**PETERSON BOULEVARD & SPACE VILLAGE AVENUE
COLORADO SPRINGS, CO**

TRAFFIC IMPACT STUDY

PROJECT NO. 017-1754

Add PCD File No. SP-17-009 & SF-18-016

FIGURE 2

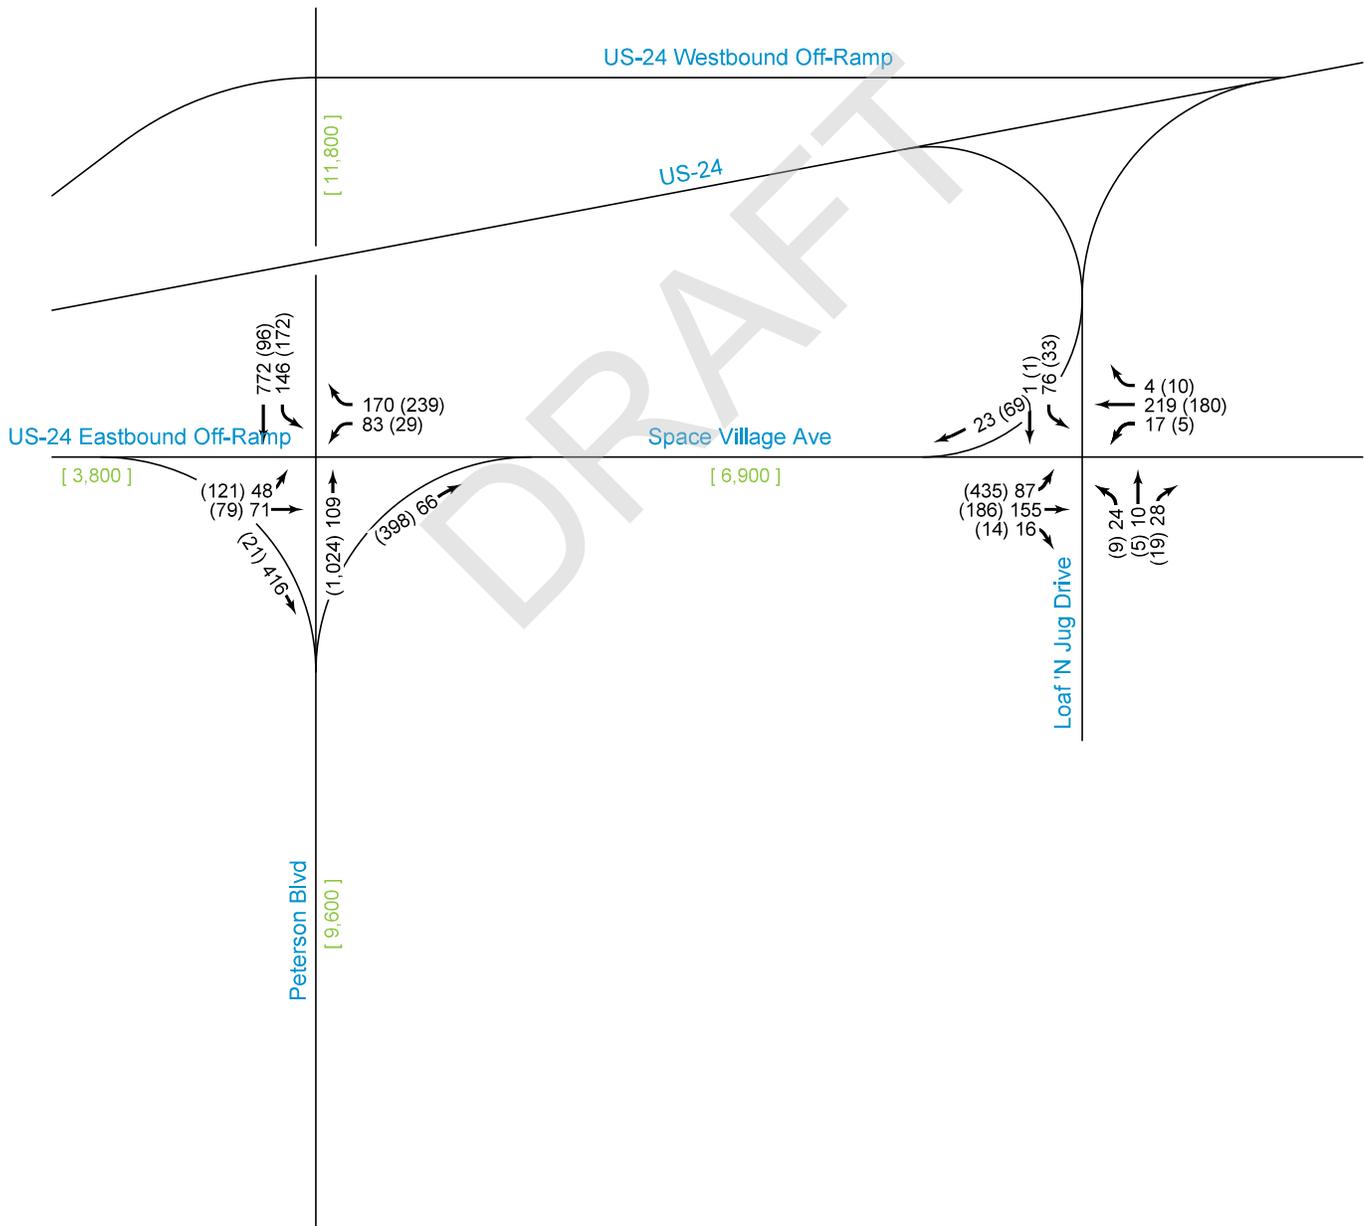
With this area involving multiple jurisdictions, for clarification identify (via narrative and/or exhibit) which jurisdiction owns/maintains which road.

FIGURE 4

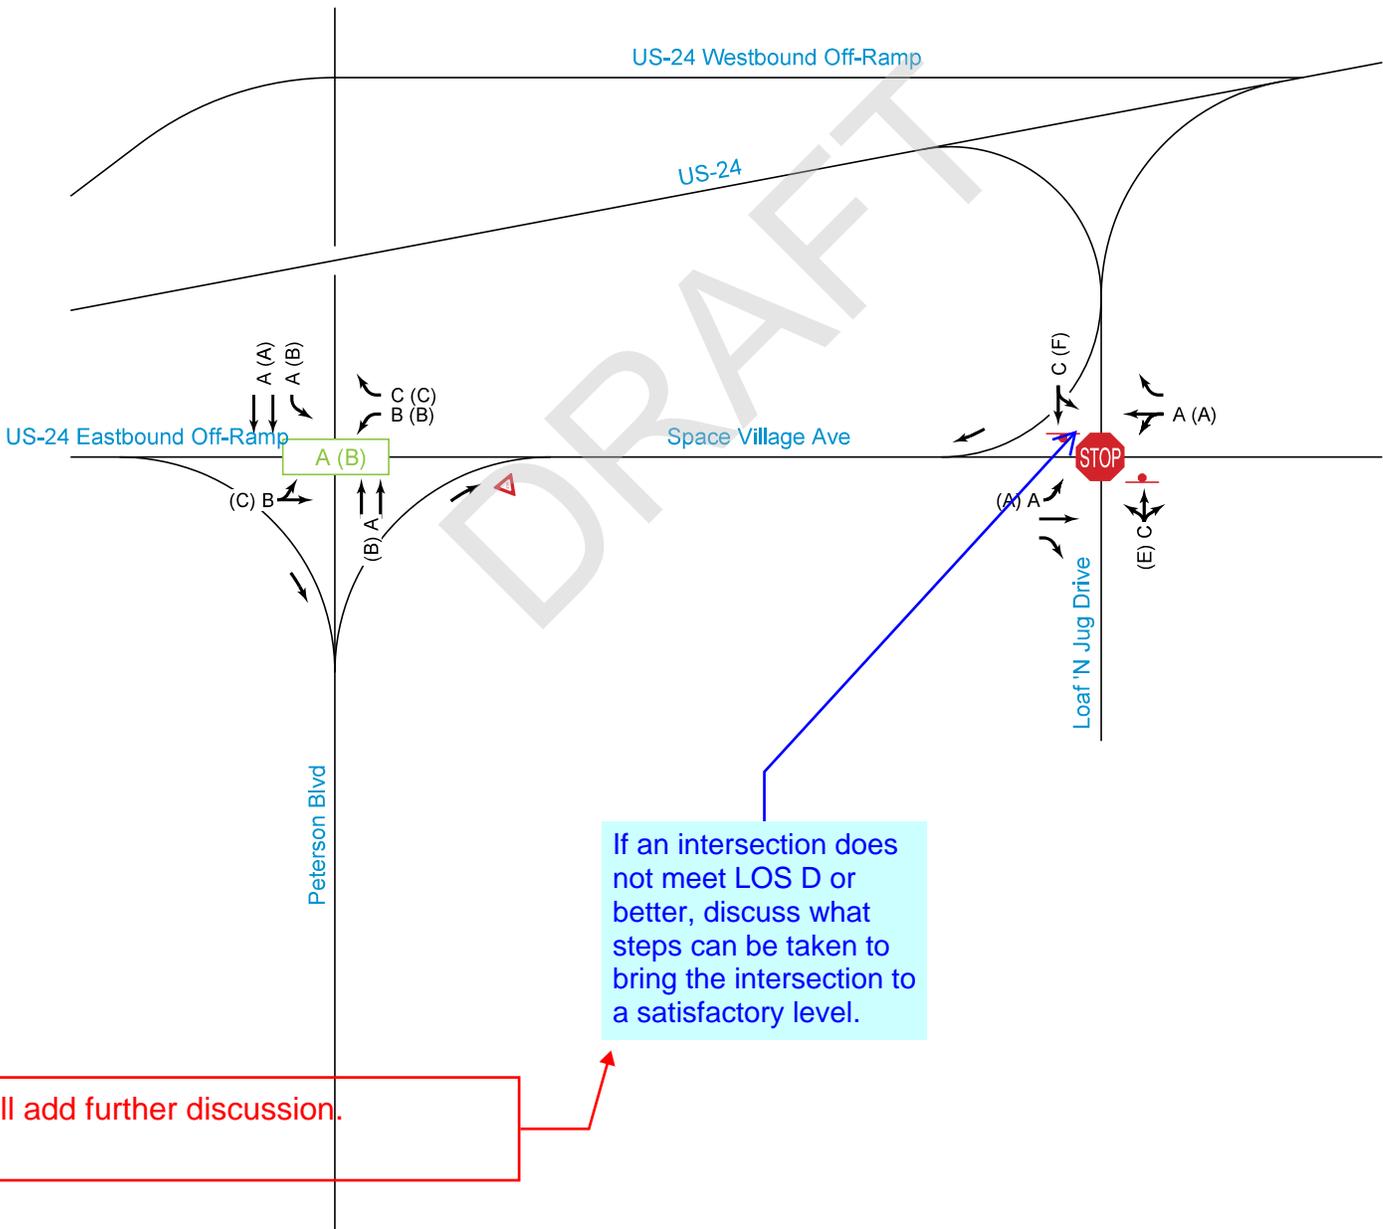
If an intersection does not meet LOS D or better, discuss what steps can be taken to bring the intersection to a satisfactory level.

Will add further discussion.

See #2 of new Section 5.0
